Access Compliance Report

Public Rights-of-Way

Intersection ID: 48438	Main Street: BARRANDS_LN	Cross Street: LATHERTON_LN	Location: NW
ADA ID: AE990C57F128	Ramp Type: BlendTrans1	Initial Pass/Fail: Fail	Overall Compliance: No
		Severity Score: 8.75

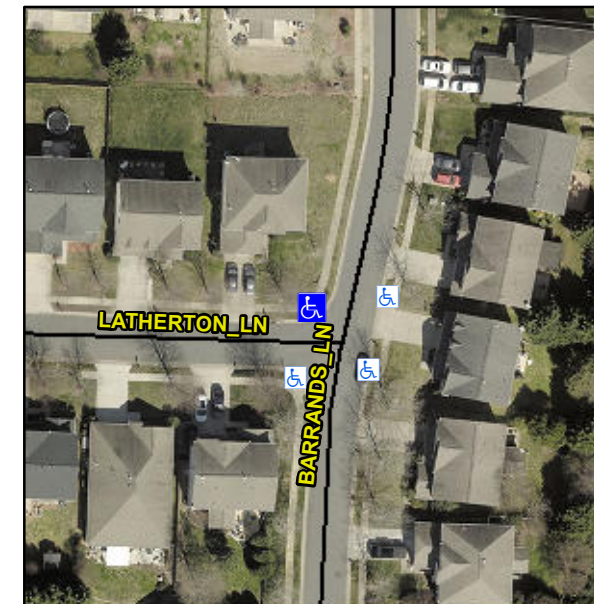
Compliance	Description	Data	Compliance	Description	Data
N/A	Ramp Length (in)	48.0	Yes	BlendTrans Slope (%)	2.1
No	Ramp Width (in)	44.0	Yes	BlendTrans XSlope (%)	1.4
N/A	Flare Type LT	N/A	N/A	Flare Type RT	N/A
N/A	Flare Slope LT (%)	N/A	N/A	Flare Slope RT (%)	N/A
N/A	Flare Traversable LT?	N/A	N/A	Flare Traversable RT?	N/A
N/A	Landing Length (in)	N/A	N/A	DWS Provided?	N/A
N/A	Landing Width (in)	N/A	N/A	DWS Contrast?	N/A
N/A	Landing Slope (%)	N/A	N/A	DWS Length (in)	N/A
N/A	Landing X Slope (%)	N/A	N/A	DWS Full Width?	N/A
N/A	Landing Curb? (Y/N)	N/A	N/A	DWS Offset (in)	N/A
N/A	Shared Landing?	N/A			
N/A	Gutter Ponding?	N/A	N/A	Gutter Slope (%)	N/A
N/A	Gutter Lip Ht (in)	N/A	N/A	Gutter X Slope (%)	N/A
N/A	Painted X Walk1?	No	N/A	Painted X Walk2?	No
	X Walk 1 Direction	To S		X Walk 2 Direction	To E
	X Walk 1 Width (in)	N/A		X Walk 2 Width (in)	N/A
	X Walk 1 Slope (%)	2.1		X Walk 2 Slope (%)	2.4
	X Walk 1 X Slope (%)	0.2		X Walk 2 X Slope (%)	0.6

N/A	Ramp inside XWalk1?	N/A	N/A	Ramp inside XWalk2?	N/A
	Road Slope (%)	0.7		Clear Space?	N/A
	Road X Slope (%)	0.5	N/A	Clear Space to XWalk (in)	N/A
N/A	Any Obstructions?	N/A	N/A	Storm Grate/Utility Hazard?	N/A
	Obstruction Type			Storm Grate/Utility Type	
		N/A			N/A
			Yes	Surface Condition? (G/P)	Good
			N/A	Curb Slope (%)	3.3

Remove & Replace Curb Ramp With Two New Directional Ramps or Equivalent.
